UNITED STATES PATENT AND TRADEMARK OFFICE

Office Action Summary	Application No. 10/518,331	Applicant(s) WIXEY ET AL.	
	Examiner Amadeus S. Lopez	Art Unit 3771

DETAILED ACTION

Figure 1

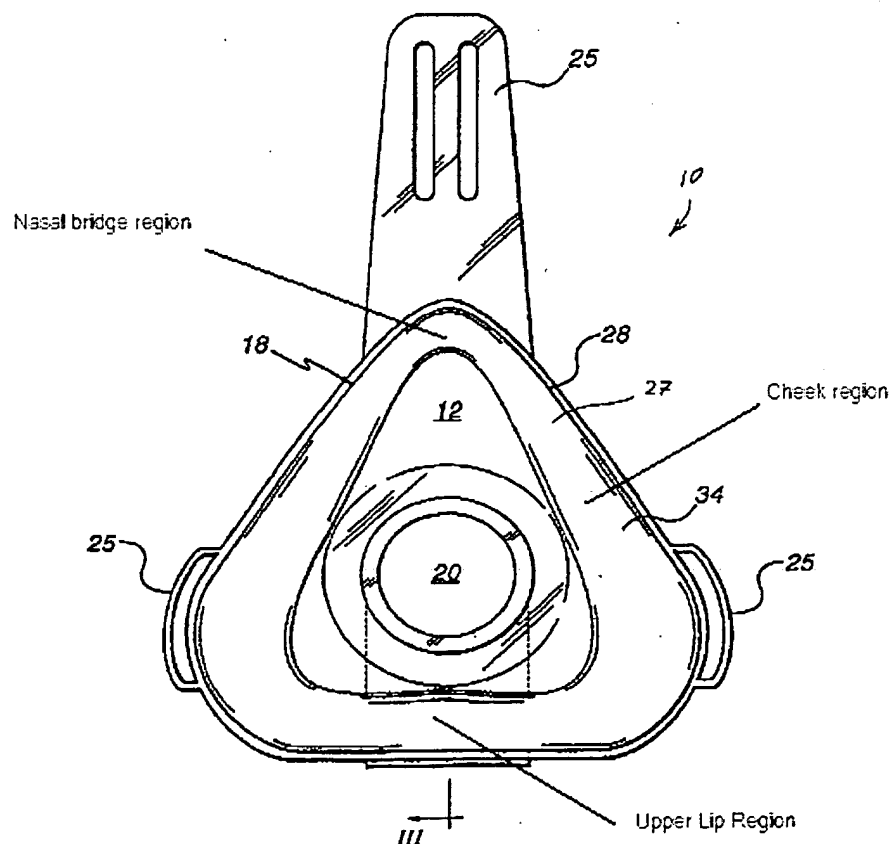
As to claims 2-4, Scarberry et al discloses a sealing interface wherein the inner sealing member has a cut out region in the nasal bridge region, in the cheek region, and the upper lip portion (labeled in figure 1 shown below).

As to claim 5, Scarberry et al discloses a sealing interface wherein the inner sealing member and the outer sealing member are continuously in contact both in use and when not in use around the facial contour contacting region (see figure 1 wherein 28 and 34 are continuously in contact).

Figure 2

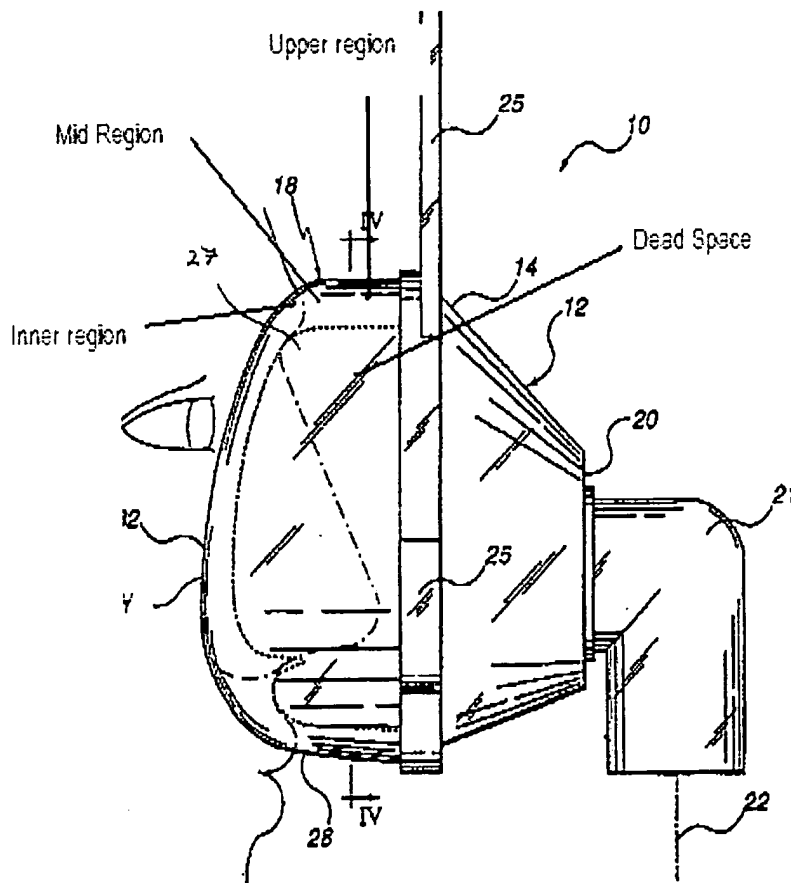
As to claim 9, Scarberry et al discloses a sealing interface wherein the nasal bridge region comprises an inner region, a middle region and an outer region whereby in use the inner region is most proximate the user (labeled in figure shown below).

As to claim 10, Scarberry et al discloses a sealing interface 9 wherein the inner region, the middle region and the outer region comprise dead space (figure 2 above shows that the disclosed regions comprise dead space within the mask labeled in the figure).

As to claim 11, Scarberry et al discloses a sealing interface wherein the inner region comprises a flexible resilient member (paragraph [0041] discloses that seal 18 which comprises both inner and outer seals 34 and 28 is "solid, yet highly resilient and self-sustaining compressible") and the middle region and the outer region comprise dead space (figure 2 shows that the disclosed regions comprise deadspace within the mask labeled in figure above).

As to claim 12, Scarberry et al discloses a sealing interface wherein the inner region and the outer region comprise a resilient deformable material (paragraph [0041] discloses that seal 18 which comprises both inner and outer seals 34 and 28 is "solid, yet highly resilient and self-sustaining compressible") and the middle region comprises dead space (figure 2 shows that the disclosed region comprise deadspace within the mask labeled in figure above).
